Mario Cuomo Bridge Path Terminus in South Nyack proposal addresses perceived danger, ignores actual danger

Design: Trowbridge Wolf Michaels Landscape Architects, 3/29/17, for the New NY Bridge / NYS Thruway Authority

Comments: Bike Tarrytown, 11/13/17

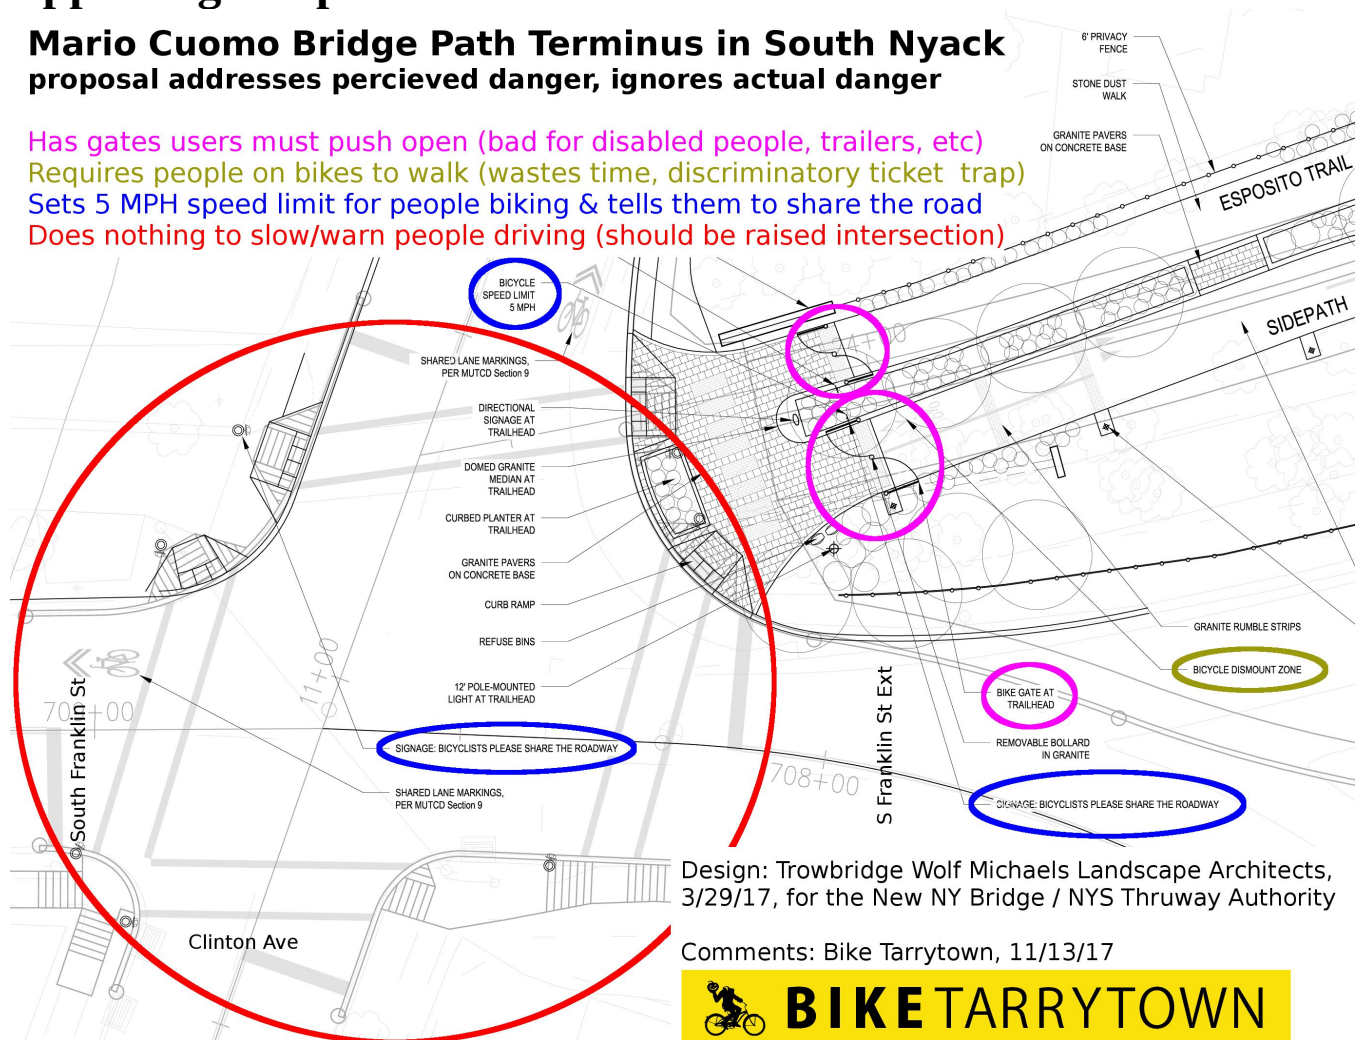
Has gates users must push open (bad for disabled people, trailers, etc)
Requires people on bikes to walk (wastes time, discriminatory ticket trap)
Sets 5 MPH speed limit for people biking & tells them to share the road
Does nothing to slow/warn people driving (should be raised intersection)

Gate detail.

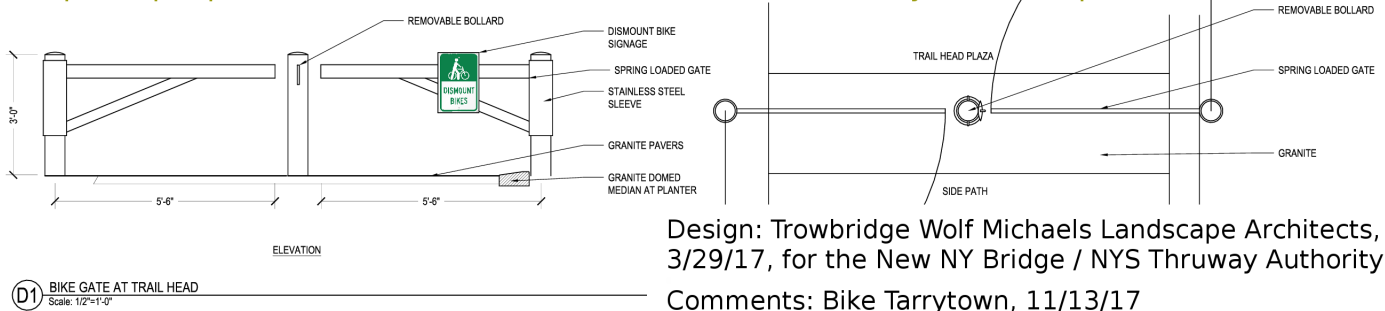
Has gates users must push open (bad for disabled people, trailers, etc)

Requires people on bikes to walk (wastes time, discriminatory ticket trap)

Where Side Path & Trail cross.

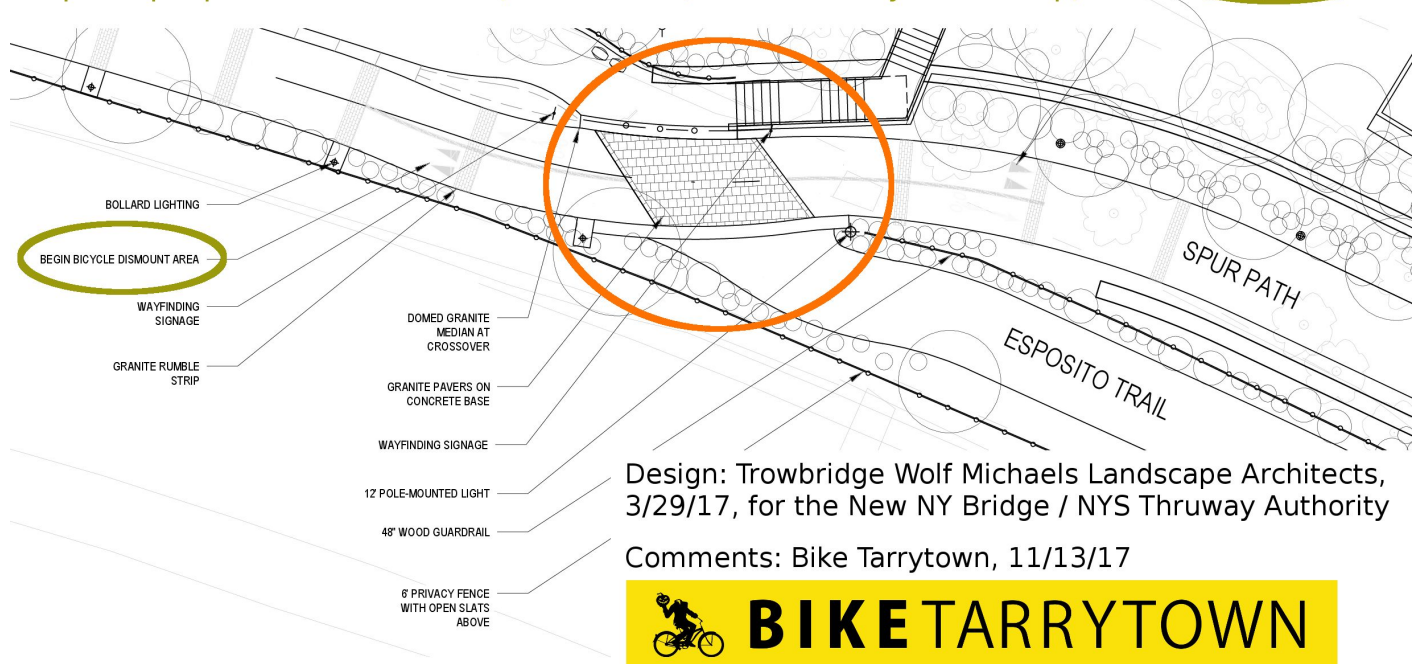
Intentionally creates conflict point

Requires people on bikes to walk (wastes time, discriminatory ticket trap)
